Access Compliance Report

Public Rights-of-Way

(Curb Ramps)

Intersection ID: 14892	Main Street: CLANTON_RD	Cross Street: SARGEANT_DR	Location: SW
ADA ID: 23C0D71A7233	Ramp Type: PerpDiag	Initial Pass/Fail: Fail	Overall Compliance: No
Severity Score: 35			
Codes/Mitigation Info/Possible Solution		Field Measurements/Component Compliance

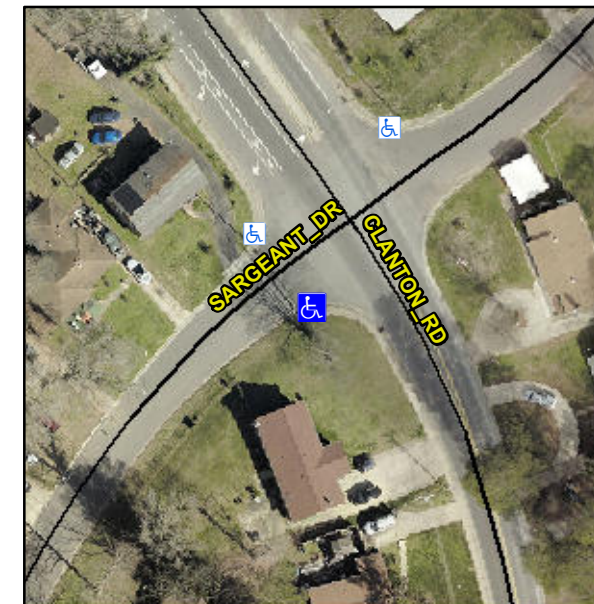
R304.5.1, R304.2.2, R304.5.3

Compliance	Description	Data	Compliance	Description	Data
N/A	Ramp Length (in)	49.0	No	Ramp Slope (%)	14.3
No	Ramp Width (in)	47.0	No	Ramp XSlope (%)	4.0
N/A	Flare Type LT	N/A	N/A	Flare Type RT	N/A
N/A	Flare Slope LT (%)	N/A	N/A	Flare Slope RT (%)	N/A
N/A	Flare Traversable LT?	N/A	N/A	Flare Traversable RT?	N/A
N/A	Landing Length (in)	N/A	N/A	DWS Provided?	N/A
N/A	Landing Width (in)	N/A	N/A	DWS Contrast?	N/A
N/A	Landing Slope (%)	N/A	N/A	DWS Length (in)	N/A
N/A	Landing X Slope (%)	N/A	N/A	DWS Full Width?	N/A
N/A	Landing Curb? (Y/N)	N/A	N/A	DWS Offset (in)	N/A
N/A	Shared Landing?	N/A			
N/A	Gutter Ponding?	N/A	N/A	Gutter Slope (%)	N/A
N/A	Gutter Lip Ht (in)	N/A	N/A	Gutter X Slope (%)	N/A
N/A	Painted X Walk1?	No	N/A	Painted X Walk2?	No
	X Walk 1 Direction	To E		X Walk 2 Direction	To N
N/A	X Walk 1 Width (in)	N/A	N/A	X Walk 2 Width (in)	N/A
	X Walk 1 Slope (%)	1.1		X Walk 2 Slope (%)	0.1
	X Walk 1 X Slope (%)	1.5		X Walk 2 X Slope (%)	0.5

Remove & Replace Curb Ramp With Two New Directional Ramps or Equivalent.
